Product Advisory (PA)

Subject: Addition of an inner box for taped packaging products of photocouplers

Publication Date: 7/7/2026

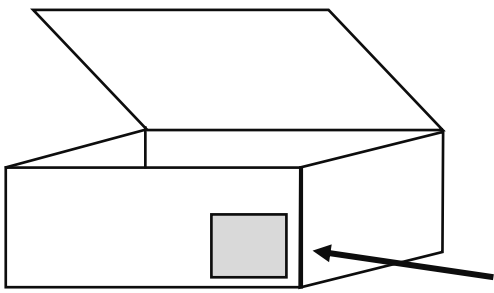
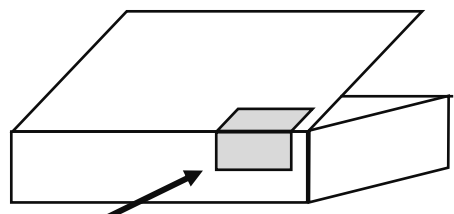
Renesas will add an inner box for taped packaging products of photocouplers.

| | Current | Addition |
| Dimensions(mm) | 335 × 335 × 95 | 347 × 368 × 63 |
| Label placement | Bottom right of the box-opening side  | Upper right of the side opposite the box-opening side  |
